COMMISSION OF ARCHITECTURAL REVIEW

APPLICATION FOR CERTIFICATE OF APPROPRIATENESS

Address 401 North Allen Avenue

See revised submission for opening in the secondary facade of the accessory structure.

LINE GRAPHIC ON GLASS CONCEPT

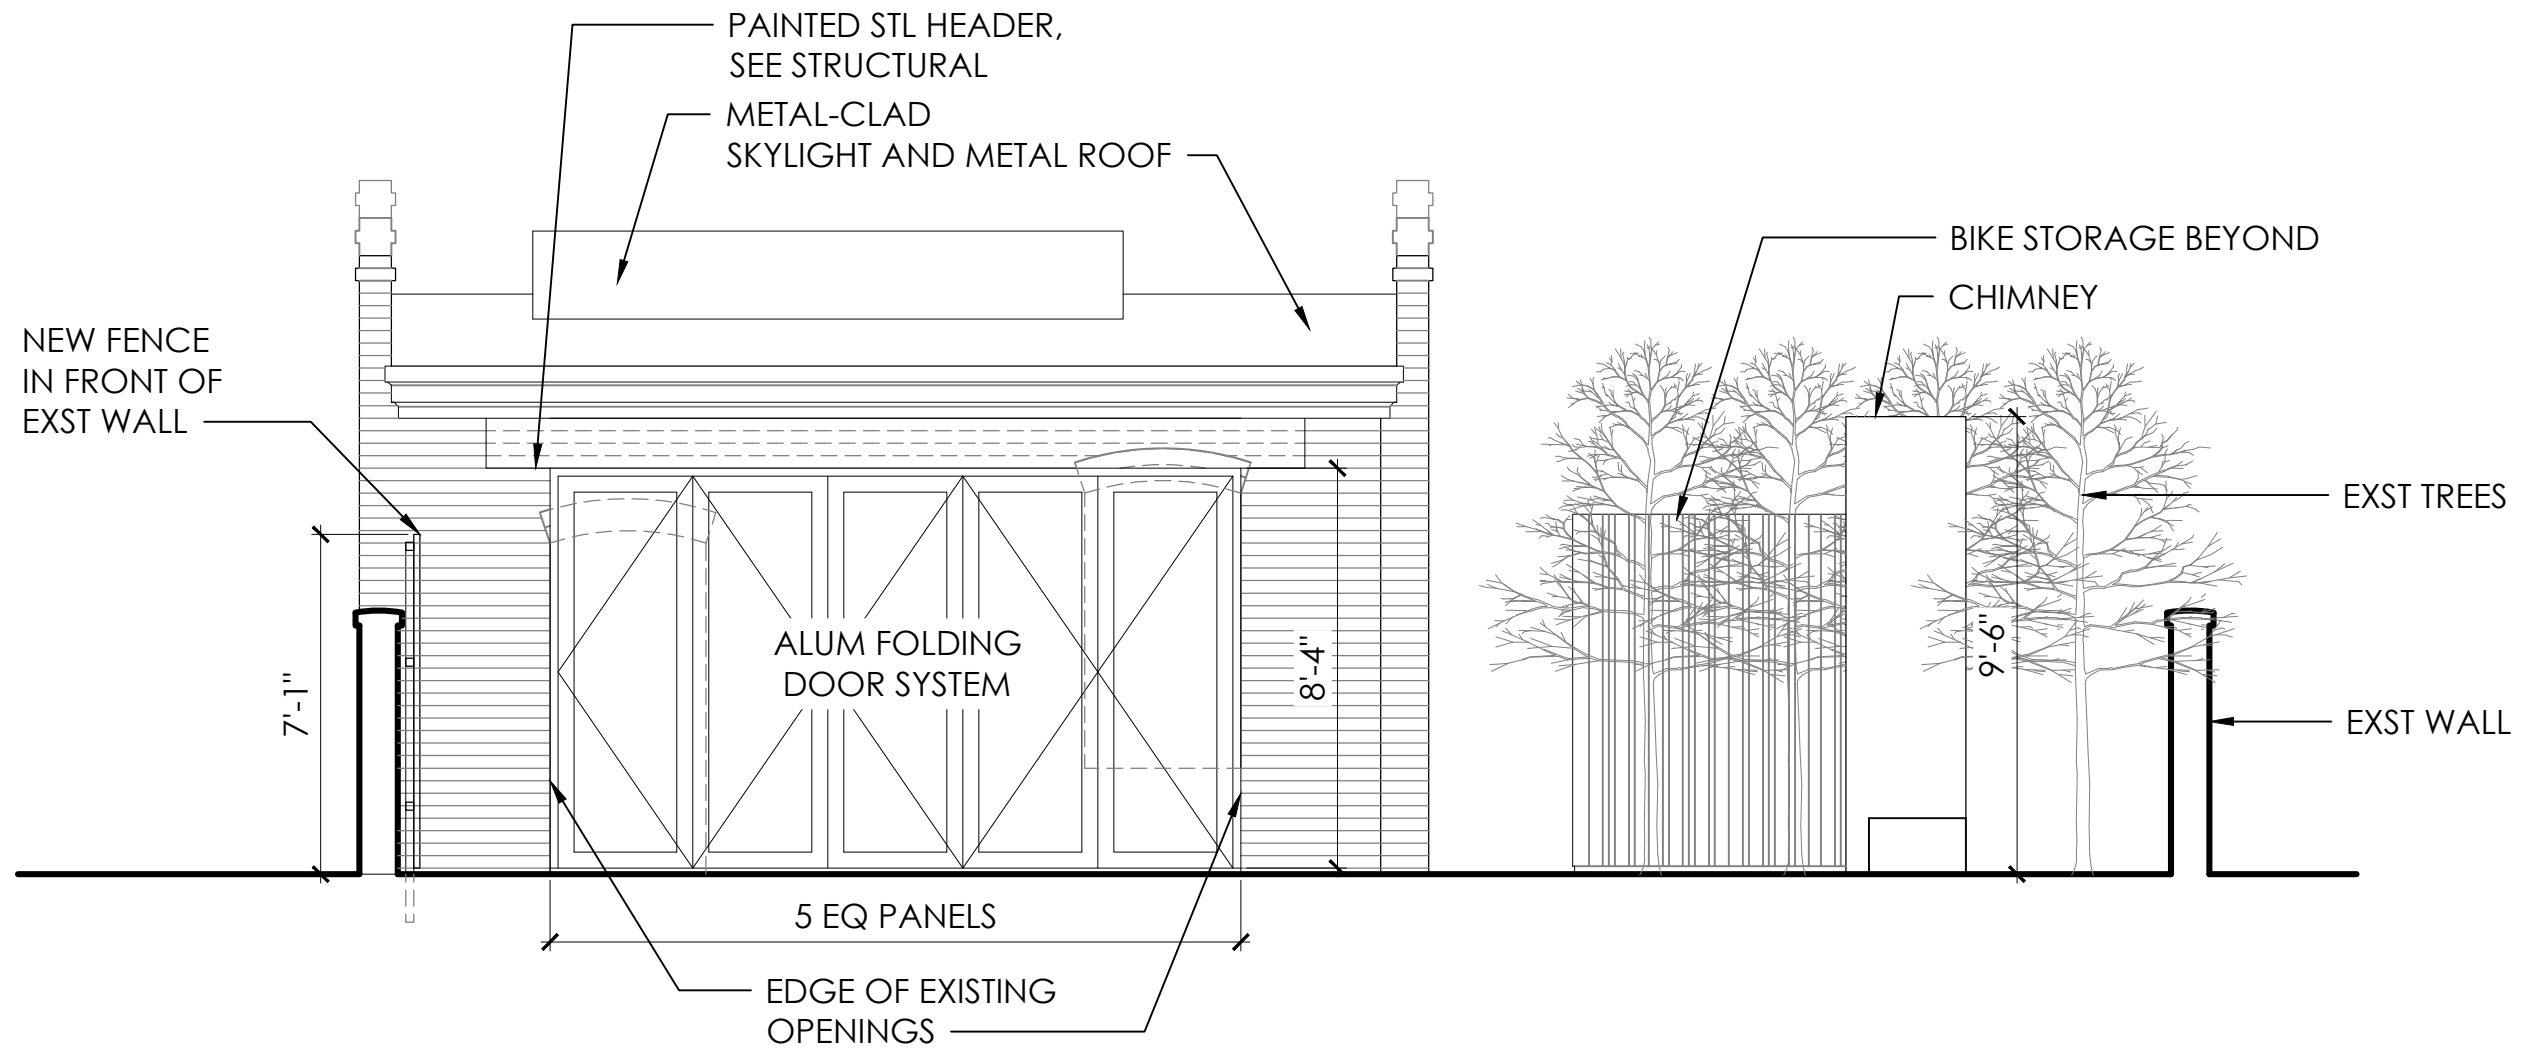
- REDUCES DOOR SYSTEM HEIGHT
- ELIMINATES VIEW OF EXPOSED STEEL BEAM (BEAM WILL BE MOUNTED ON INTERIOR, PRESERVING MORE EXTERIOR BRICK)
- MAINTAINS ODD-NUMBER OF PANELS WHICH IS REQUIRED FOR FUNCTION OF DOOR SYSTEM
- MAINTAINS COMFORTABLE PANEL WIDTH FOR INGRESS TO CARRIAGE HOUSE THROUGH ONE PANEL WHEN SYSTEM IS CLOSED
- DEMARCATES ORIGINAL OPENINGS THROUGH LINE GRAPHIC APPLIED TO GLAZING

FRIT GLASS CONCEPT

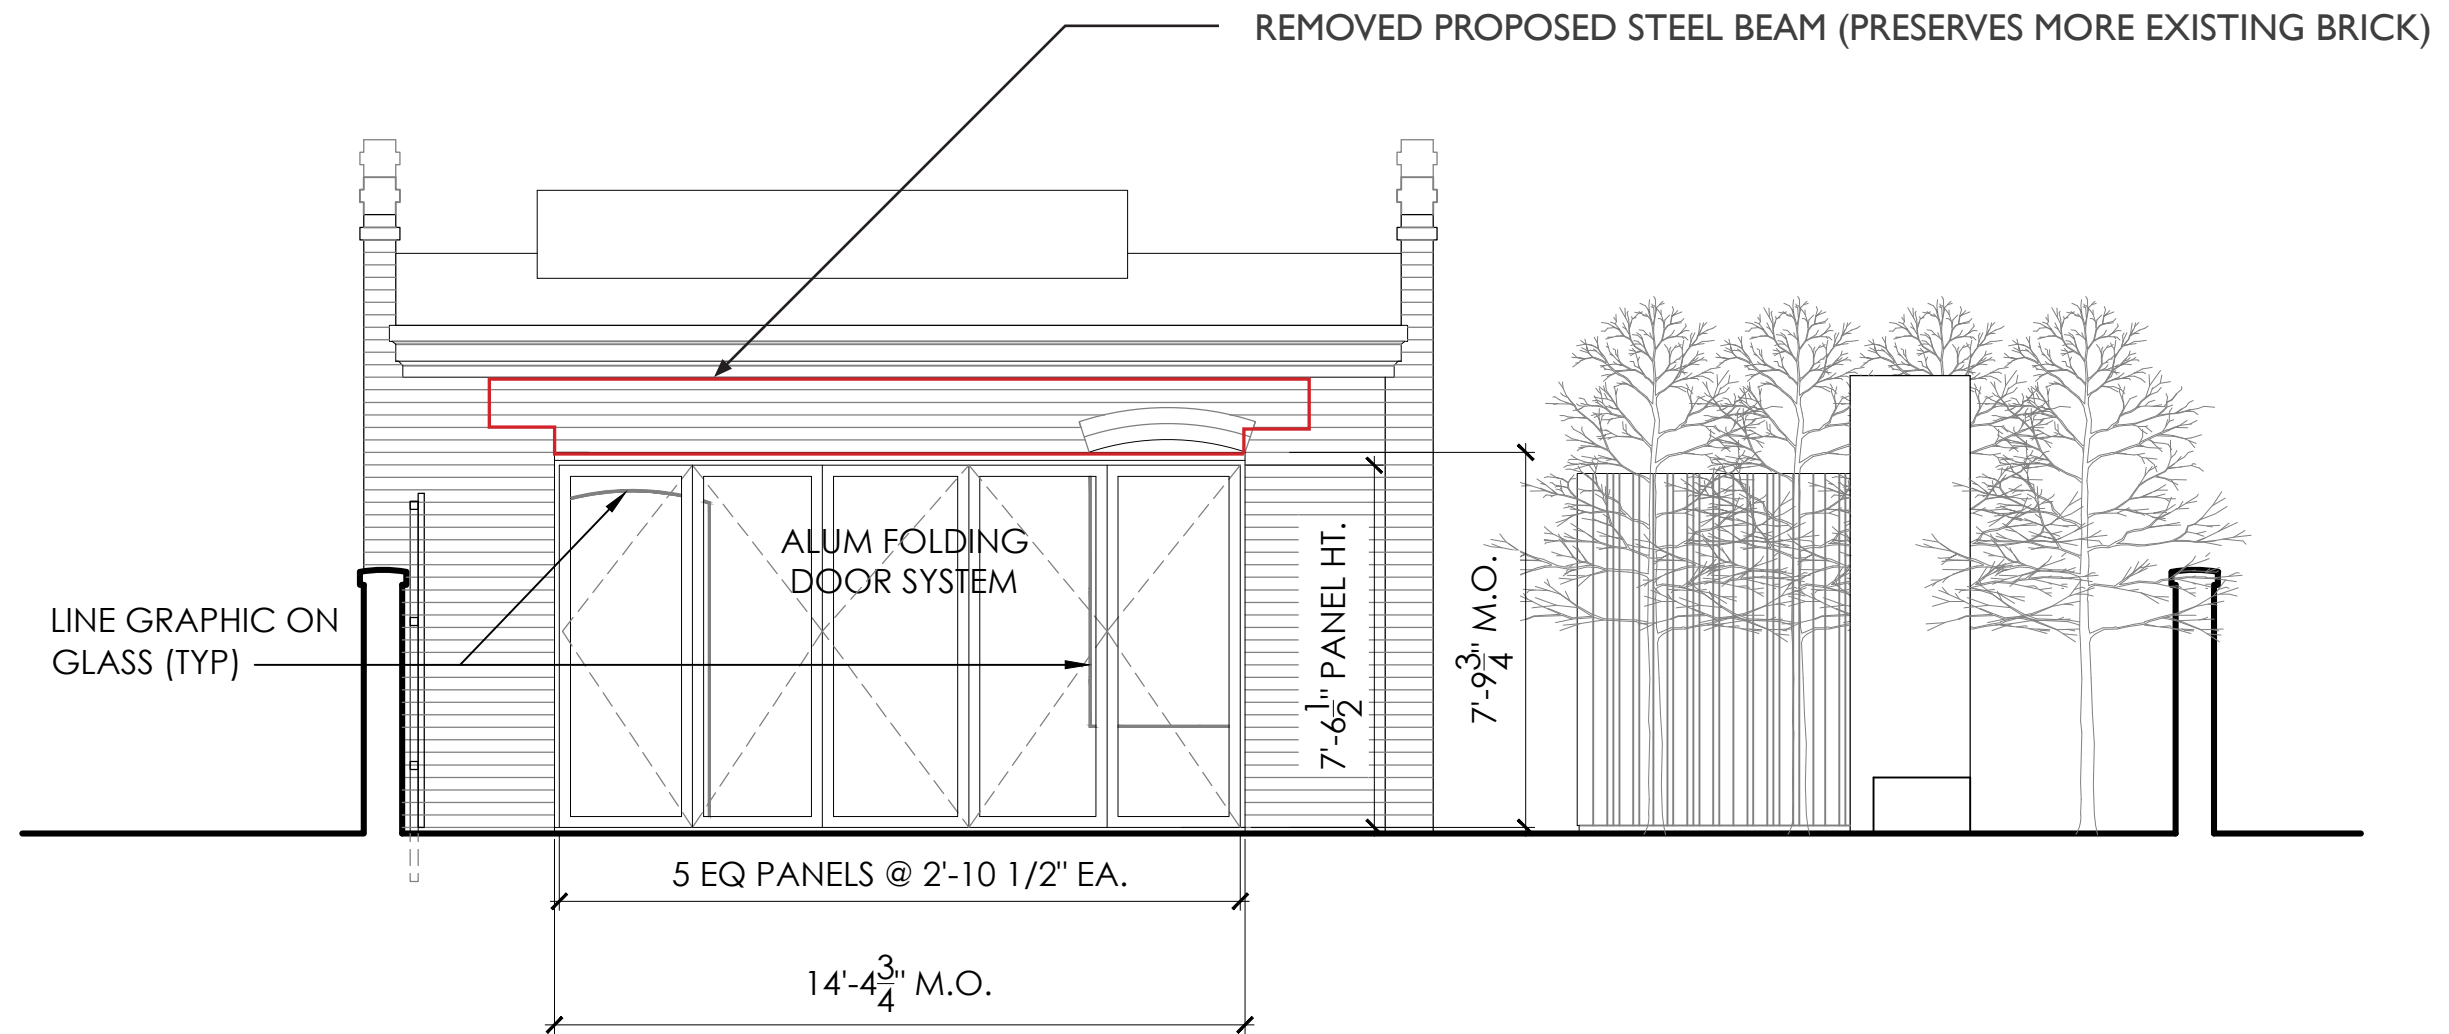
- REDUCES DOOR SYSTEM HEIGHT (SIMILAR TO ALT. 1)
- ELIMINATES VIEW OF EXPOSED STEEL BEAM (BEAM WILL BE MOUNTED ON INTERIOR, PRESERVING MORE EXTERIOR BRICK)
- MAINTAINS ODD-NUMBER OF PANELS WHICH IS REQUIRED FOR FUNCTION OF DOOR SYSTEM
- MAINTAINS COMFORTABLE PANEL WIDTH FOR INGRESS TO CARRIAGE HOUSE THROUGH ONE PANEL WHEN SYSTEM IS CLOSED
- DEMARCATES THE ENTIRE PROFILE OF THE ORIGINAL OPENINGS THROUGH FRIT PATTERN GRAPHIC APPLIED TO GLAZING, COMMUNICATING A UNIQUE REPRESENTATION OF OLD AND NEW

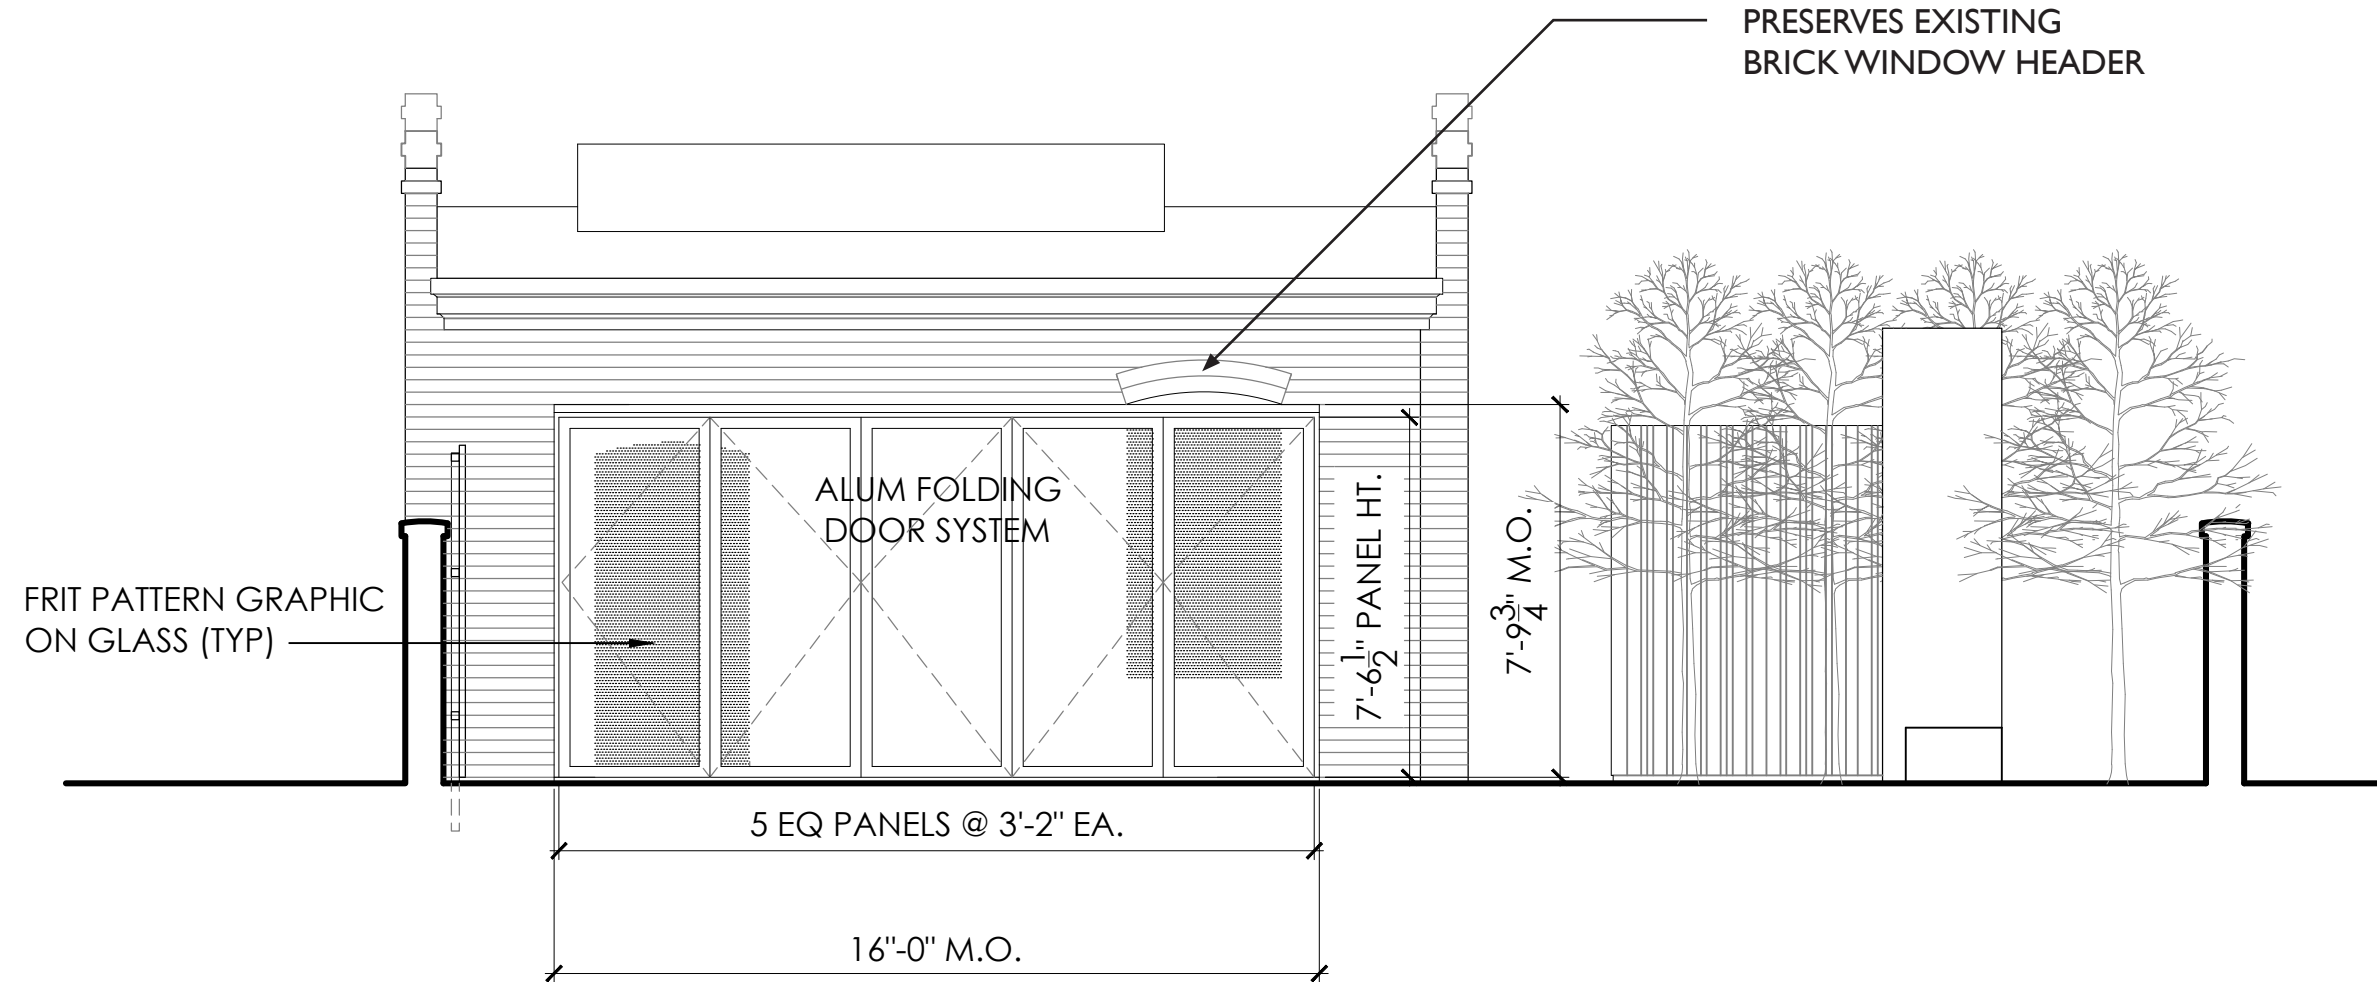
- PER COMMITTEE SUGGESTION, DOOR SYSTEM DOES NOT ALTER EXISTING DOOR OPENING
- THE EXISTING DOOR OPENING WOULD NEED TO BE FILLED WITH MASONRY/STUCCO TO PROVIDE STRUCTURE AT NEW DOOR SYSTEM JAMB, THUS DECREASING OVERALL DAYLIGHT INTO THE INTERIOR
- PANEL WIDTH IS OVERSIZED AND CUMBERSOME FOR INGRESS TO CARRIAGE HOUSE THROUGH ONE PANEL WHEN SYSTEM IS CLOSED
- WIDE PANELS EXTEND INTO OUTDOOR SPACE AND OBSTRUCTS USE OF OUTDOOR DINING SPACE
- AWKWARD COMPOSITION OF ORIGINAL AND NEW OPENINGS

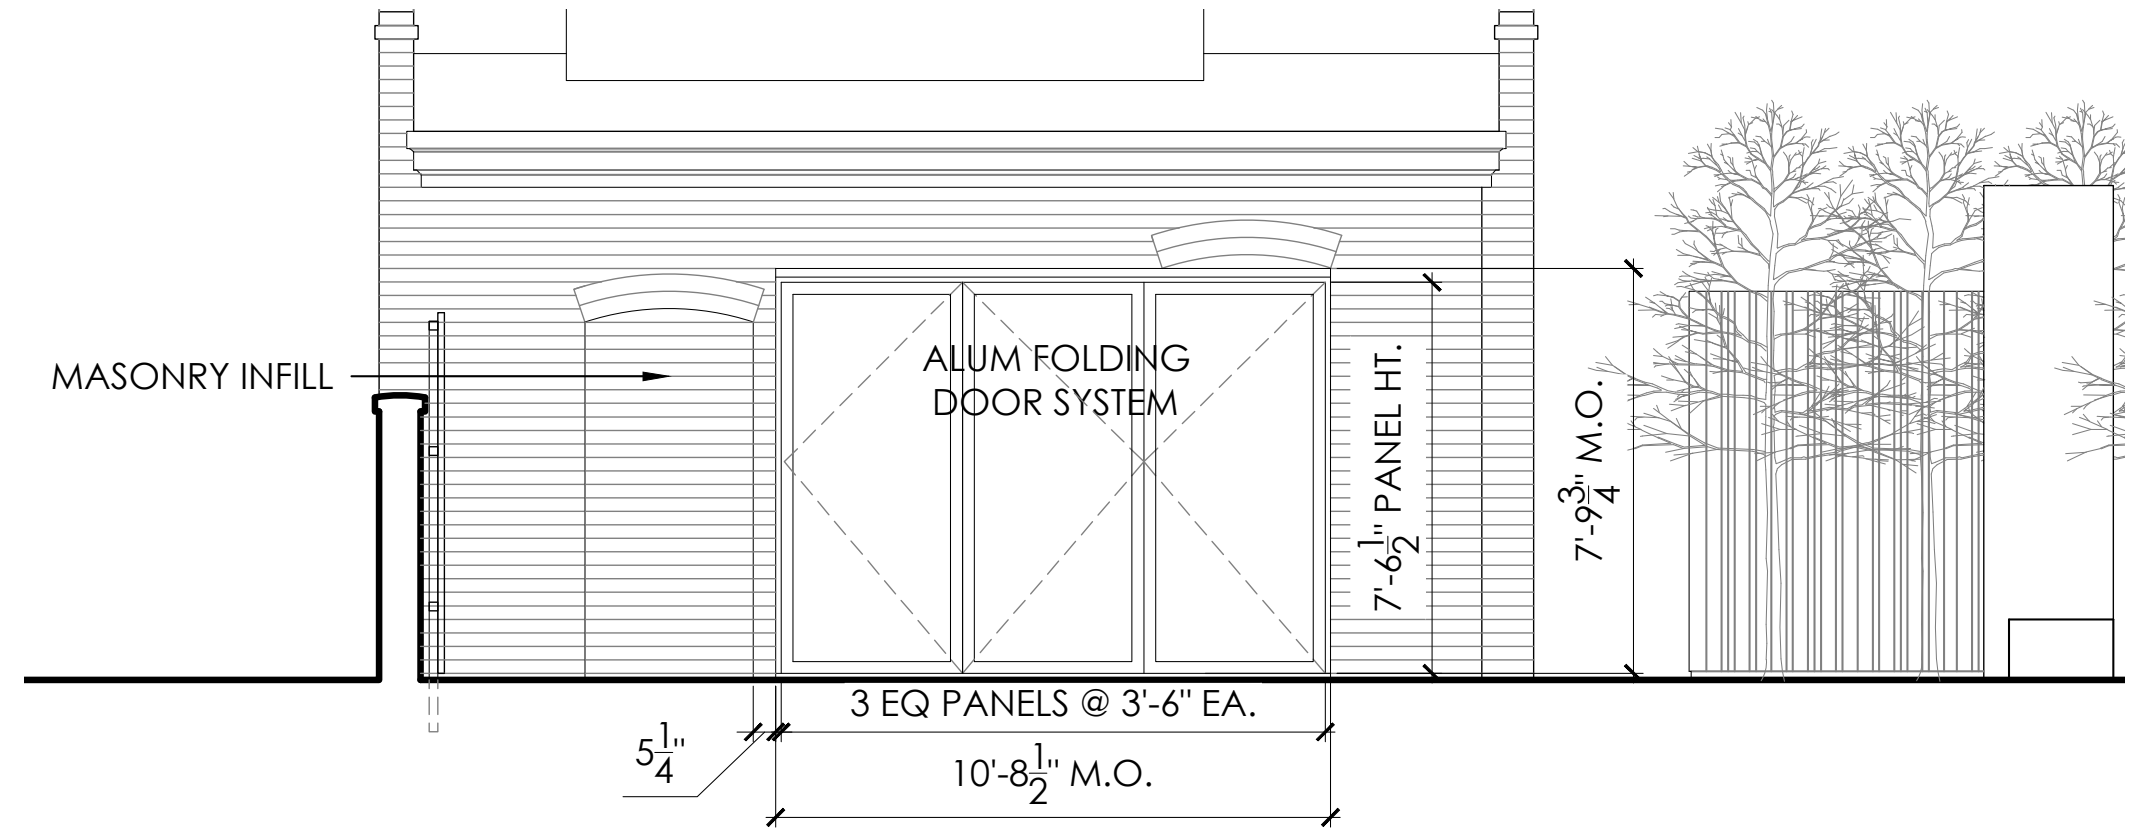
- PER COMMITTEE SUGGESTION, DOOR SYSTEM IS REDUCED IN WIDTH
- THE EXISTING DOOR OPENING WOULD NEED TO BE FILLED WITH MASONRY/STUCCO TO PROVIDE STRUCTURE AT DOOR SYSTEM JAMB, DECREASING DAYLIGHT INTO THE INTERIOR
- MAINTAINS ODD-NUMBER OF PANELS WHICH IS REQUIRED FOR FUNCTION OF DOOR SYSTEM
- PANEL WIDTH IS UNDERSIZED AND NARROW FOR INGRESS TO CARRIAGE HOUSE THROUGH ONE PANEL WHEN SYSTEM IS CLOSED
- AWKWARD FRAGMENTS OF THE ORIGINAL OPENINGS REMAIN
